## Planning Commission Staff Report

**SUBJECT:** DR18-34, RETAIL CENTER AT SANTAN VILLAGE

DR18-34: Retail Center at San Tan Village  
Attachment 4 - Site Plan  
June 6, 2018

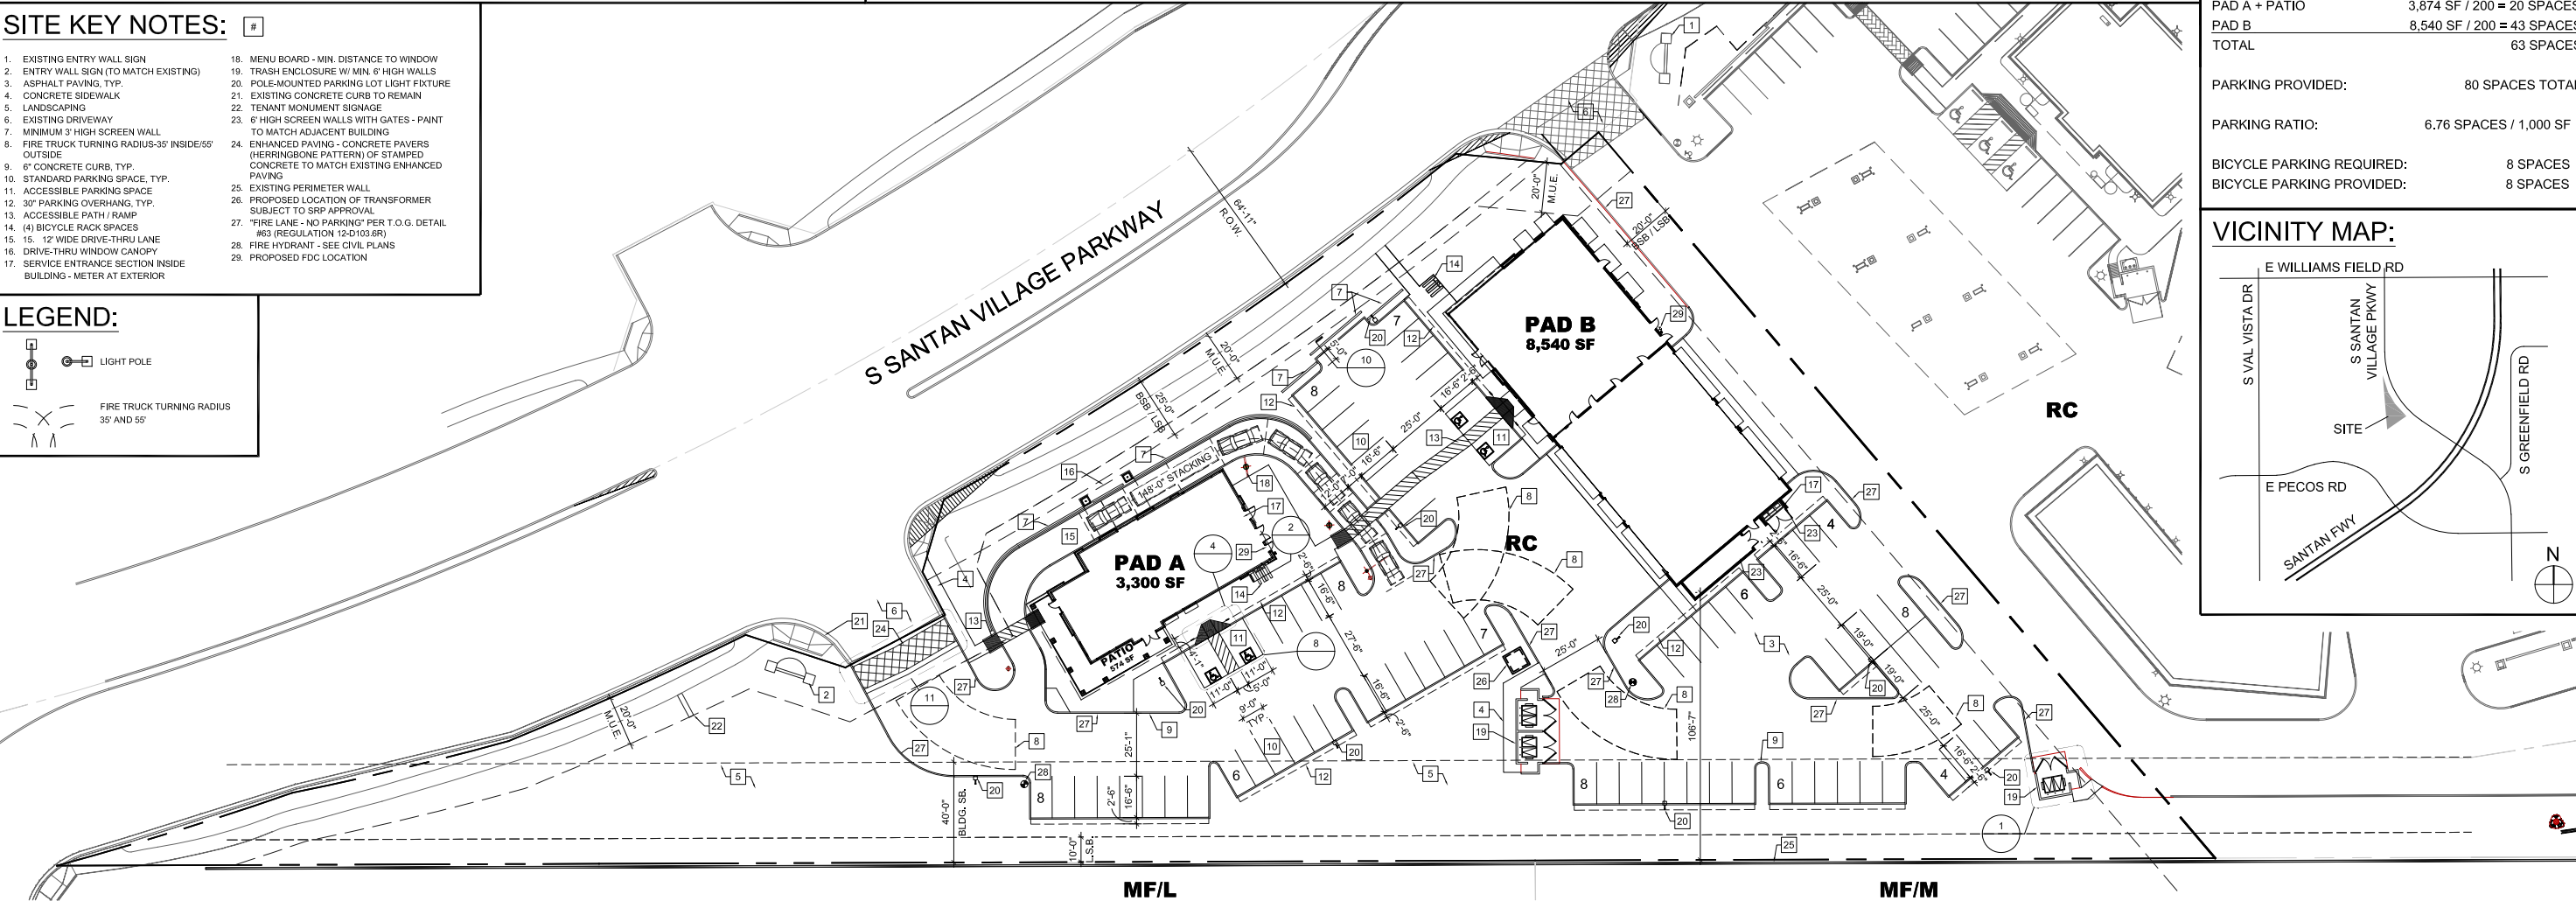
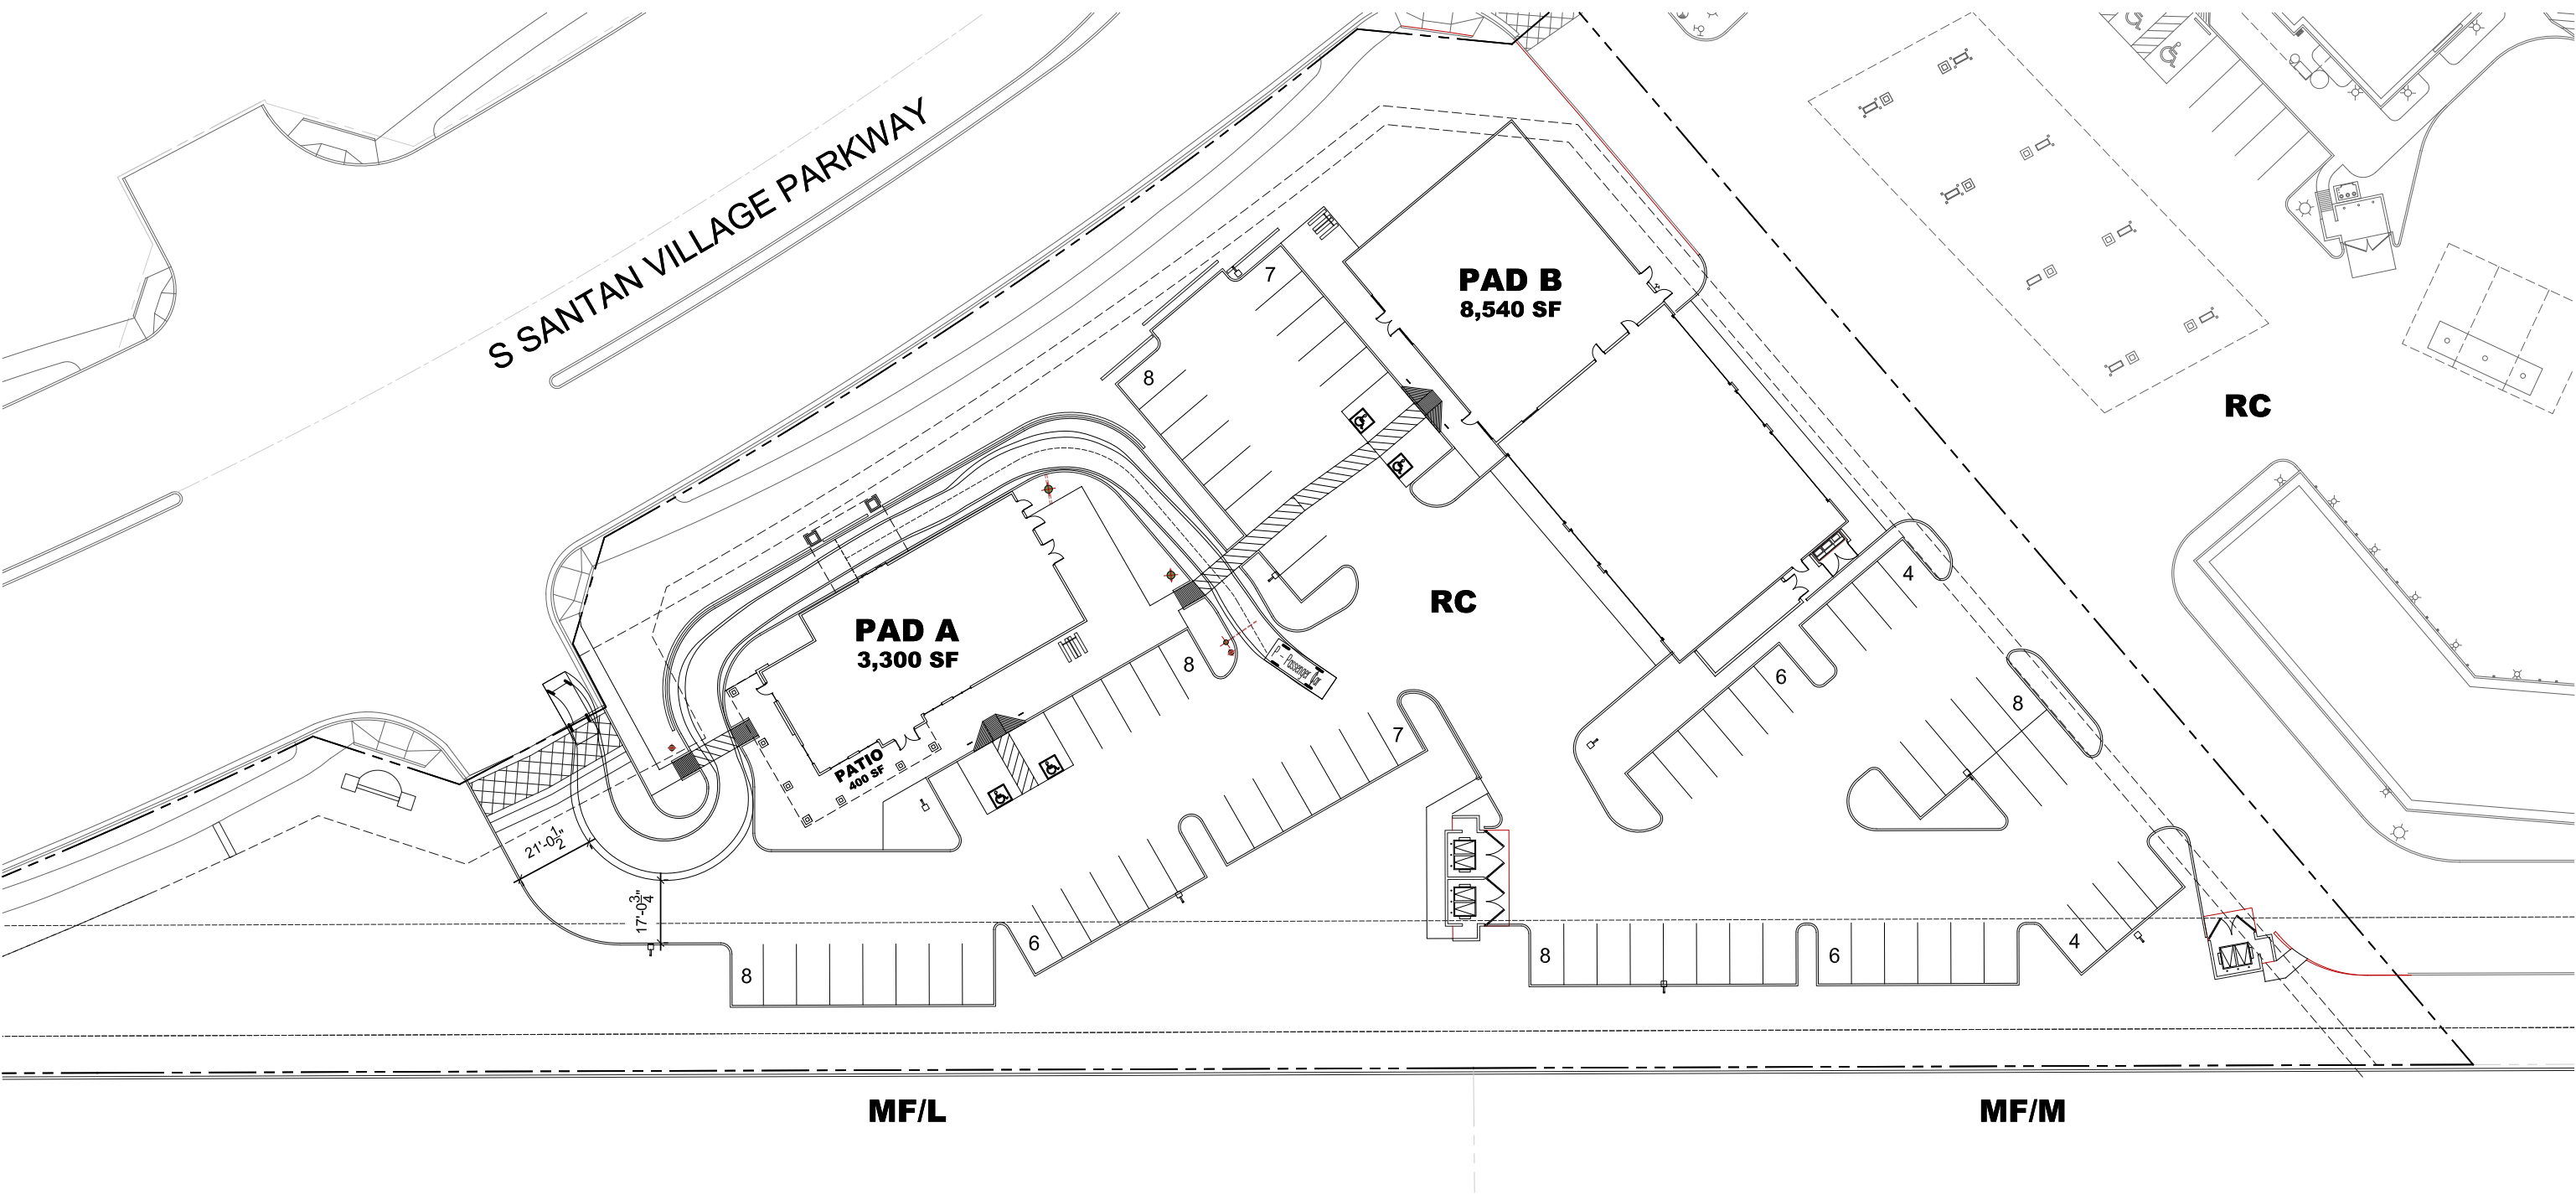
1. Commissioners discussed the drive-thru exit on Pad A and vehicles entering the site at the north entrance.
  - The project was evaluated for a safe drive-thru exit. A turning movement was provided showing the vehicle movement exiting the drive-thru, with still enough width for a vehicle to enter the site off of Santan Village Parkway while a vehicle is exiting the drive-thru.

2. Commissioners were concerned with ADA accessible route around Pad A.
  - The drawings were revised to show that the patio area will not be fully enclosed, providing adequate ADA access. A column has been relocated to provide enough spacing between the entrance and closest parking space overhang.

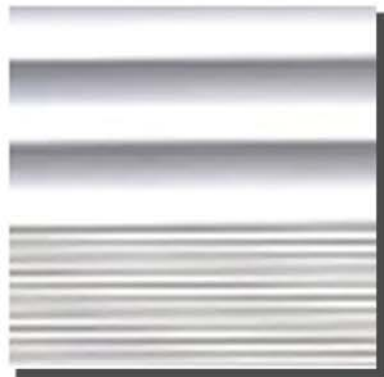
Change to "Modesto"
